Federal Emergency Management Agency

Case No.: 08-01-0505P
Community Name: City of Bristol, CT
Community No.: 090023
Effective Date of
This Revision: **June 11, 2008**

LETTER OF MAP REVISION DETERMINATION DOCUMENT

Flooding Source	Effective Flooding	Revised Flooding	Increases	Decreases
Pequabuck River	Zone A1-A30	Zone A1-A30	NONE	YES
	BFEs*	BFEs	NONE	YES
	Floodway	Floodway	NONE	YES

MAP REFERENCE NOTES:

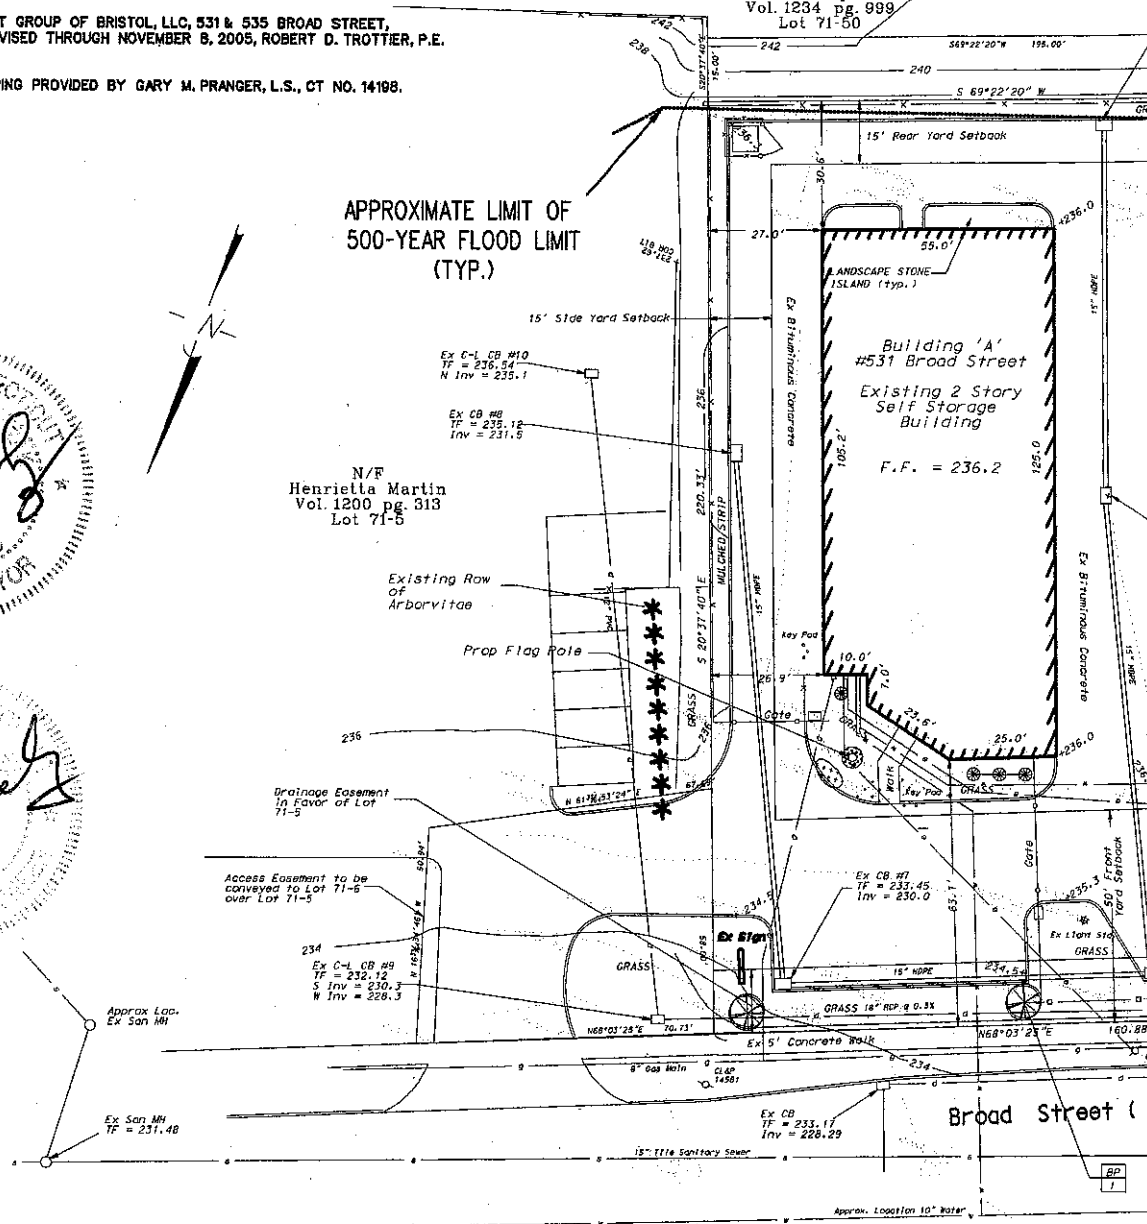
- d. The submitted corrected effective HEC-RAS model appears to cite a span of 77 feet for Bridge Number 05594, while the certified topographic work map entitled "Pequabuck River Floodplain & Floodway in Vicinity of Bridge No. 05594," prepared by EcoDesign, LLC, dated January 18, 2008, appears to cite a bridge span of 74.5 feet. Please explain or correct the inconsistency.

3. Please revise the above-referenced topographic work map as follows and resubmit a hard copy.
 - a. Please revise the boundary delineations based on the above-referenced revisions to the hydraulic model.

- b. Please extend the scope of the topographic work map to encompass the entire area of revision in the HEC-RAS model and to show the tie-ins between the revised conditions boundary delineations and the effective boundary delineations at the upstream and downstream ends of the revised reach.

- c. Please include the revised conditions and the effective base floodplain, 0.2-percent-annual-chance floodplain, and regulatory floodway boundary delineations on the topographic work map.
